## Memorandum

**Subject:** Park Avenue Housing – **Project No.** 4036  
DRC design compliance & Permit Follow-up

## **Revision Summary**

# "AS PERMITTED" - JULY 11, 2013 PERMIT SET

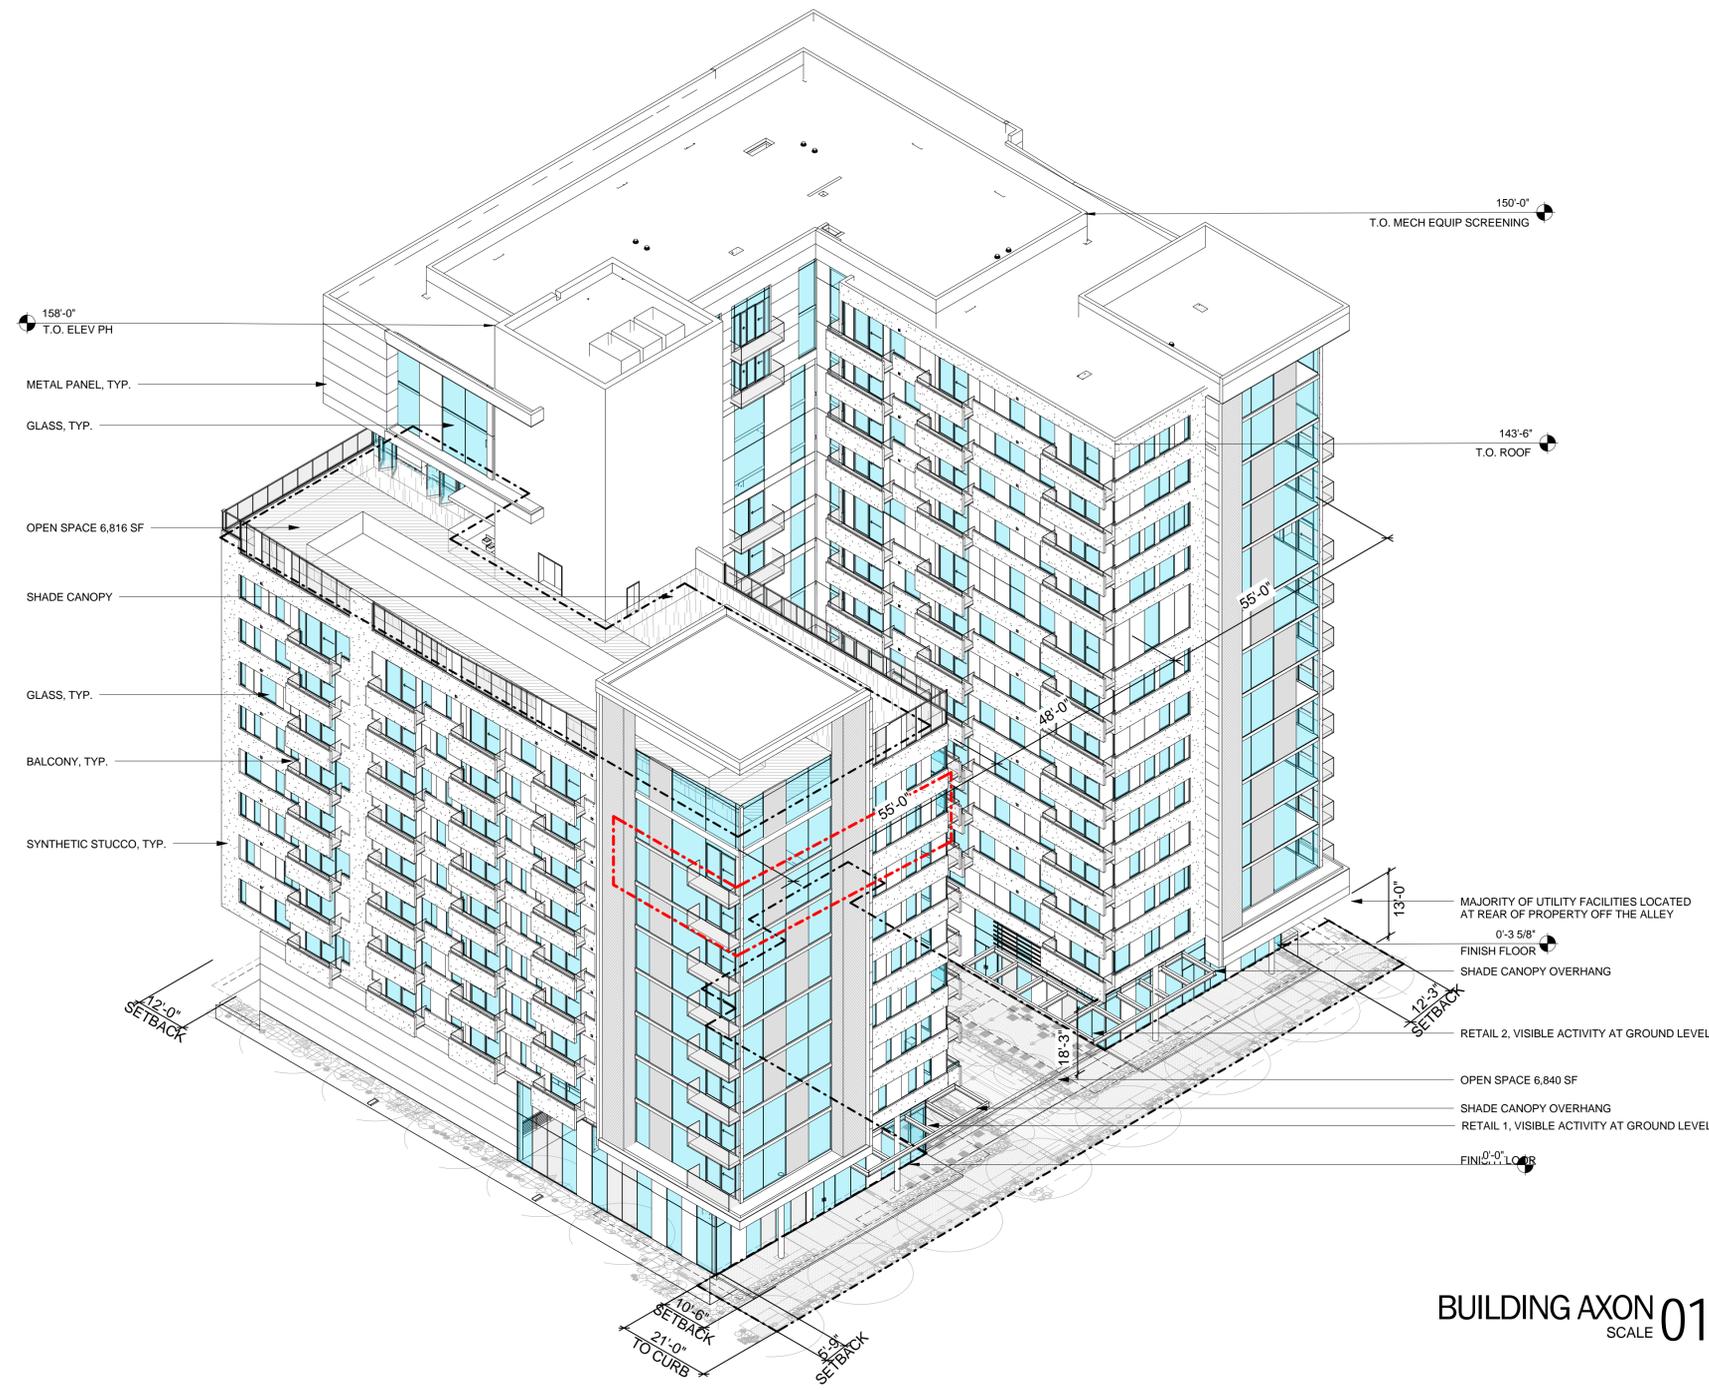
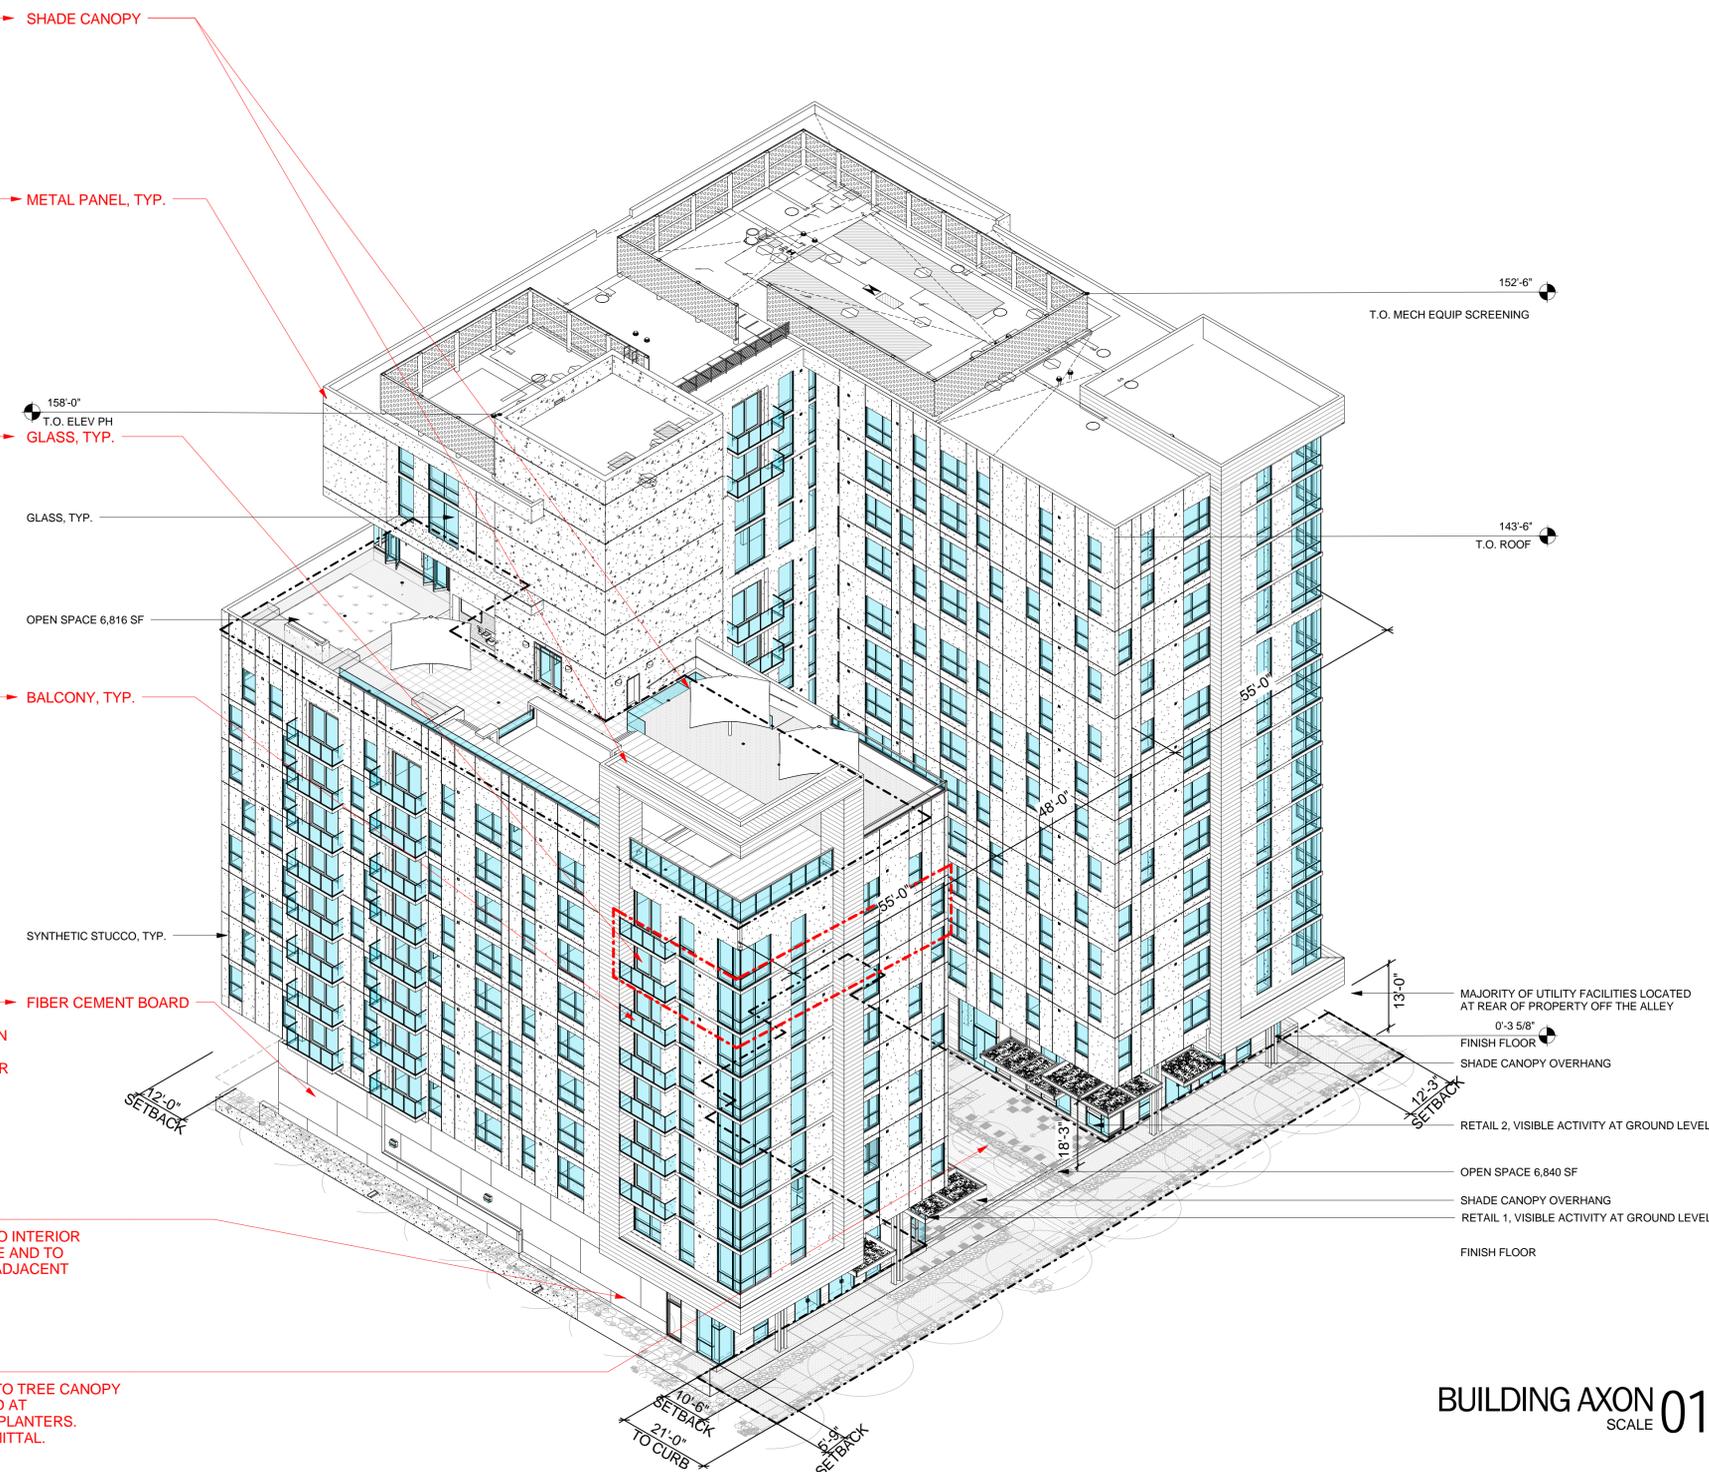
- Revision 1: Added an iconic shade canopy added at amenity deck to complement shade structures. In an attempt to reduce the scale of the building, provide shade on the amenity deck, and reduce the perceived "building mass," we extended the originally proposed "eye brow" of the south façade as an integrated shading element for the roof deck.

- Revision 2: Horizontal volume on Level 12 and level 13 has been revised from the proposed metal panel to synthetic stucco to coordinate with the composition of the corners on Park Ave.

- Revision 3: The energy modeling and analysis required that glazing be reduced on the entire building – this was not driven by a cost savings measure. The slight reduction in square footage of glass on the building exterior provides a more energy efficient façade that was acceptable to the 2012 International Energy Conservation Code (IECC) and City of Tucson Com-Check.

- Revision 4: Balcony locations revised from Park Ave (East Elevation) to North, South, and West elevations with additional updates in courtyard to control activity concerns expressed in DRC review. Level 12 and level 13 North East balconies have been revised from full depth to a reduced Juliet balcony. Which DRC stated in our review discussions, that they would prefer.

- Revision 5: On the North, West, and South facades the Level 1 wall has been revised from board formed concrete wall to a colored fiber cement board panel to provide a more friendly material at pedestrian level.

- Revision 6: Storefront glazing relocated to interior courtyard to active public space and to provide visual separation from adjacent parking lot for retail tenant.

- Revision 7: Overhead shade trellis has been revised to tree canopies with landscape lighting provided at pedestrian level in benches and planters.

- 1 SHADE CANOPY REVISION**
  - ICONIC SHADE CANOPY REVISED AT AMENITY DECK TO COMPLEMENT ADDED SHADE STRUCTURES.
- 2 MATERIAL REVISION**
  - HORIZONTAL VOLUME ON LEVEL 12 AND LEVEL 13 HAS BEEN REVISED FROM THE PROPOSED METAL PANEL TO EIFS TO COORDINATE WITH THE COMPOSITION OF THE CORNERS ON PARK AVE. METAL PANEL RELOCATED TO PARK AVE ELEVATION.

- 3 GLAZING REVISION**
  - GLAZING WAS REVISED TO PROVIDE A MORE ENERGY EFFICIENT FAÇADE THAT WAS ACCEPTABLE TO THE 2012 INTERNATIONAL ENERGY CONSERVATION CODE (IECC) AND CITY OF TUCSON COM-CHECK.

- REFER TO GLAZING STUDY.
- 4 BALCONY REVISION**
  - BALCONY LOCATIONS REVISED FROM PARK AVE (EAST ELEVATION) TO NORTH, SOUTH, AND WEST ELEVATIONS WITH ADDITIONAL UPDATES IN COURTYARD TO CONTROL ACTIVITY CONCERNS EXPRESSED IN DRC REVIEW.

- LEVEL 12 AND LEVEL 13 NORTH EAST BALCONIES (2 TOTAL) HAVE BEEN REVISED FROM FULL DEPTH TO A REDUCED JULIET BALCONY. REFER TO IMAGES ON PAGE 3 OF 3 FOR LOCATION.

- 5 MATERIAL REVISION**
  - ON THE NORTH, WEST, AND SOUTH FAÇADES THE LEVEL 1 WALL HAS BEEN REVISED FROM BOARD FORMED CONCRETE WALL TO A COLORED FIBER CEMENT BOARD PANEL TO PROVIDE A MORE FRIENDLY MATERIAL AT PEDESTRIAN LEVEL.

- 6 GLAZING REVISION**
  - STOREFRONT GLAZING RELOCATED TO INTERIOR COURTYARD TO ACTIVE PUBLIC SPACE AND TO PROVIDE VISUAL SEPARATION FROM ADJACENT PARKING LOT FOR RETAIL TENANT.

- 7 LANDSCAPE REVISION**
  - OVERHEAD SHADE TRELLIS REVISED TO TREE CANOPY WITH LANDSCAPE LIGHTING PROVIDED AT PEDESTRIAN LEVEL IN BENCHES AND PLANTERS.

GLAZING WAS REVISED FROM 56% TO 46% PROVIDING A TOTAL DELTA OF 10% REVISION TO COMPLY WITH ENERGY EFFICIENCY REQUIRED PER 2012 IECC.
